03346 Version 3

Product Update: 2006 Ridgeline Inner Door Handle Cable End Clip

(Supersedes 06-012, dated April 29, 2016, to revise the information highlighted in yellow.)

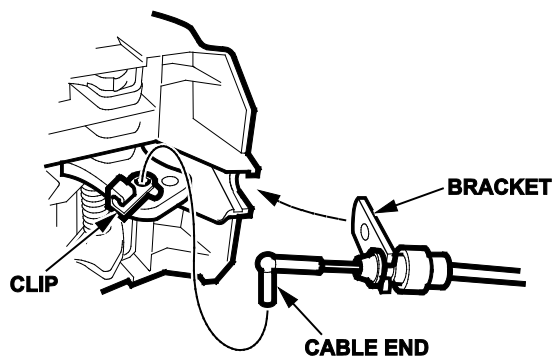
1. Remove the inner door handle. Refer to the service information.
2. Remove the cable bracket screw and detach the inner handle cable from the inner handle (right rear inner handle is shown).

3. Separate the cable end from the clip (snap).

4. Install the cable end into the new handle and secure the clip to the cable end.
5. Reinstall all parts in reverse order of removal.
6. Repeat steps 1 through 5 for the remaining three doors.
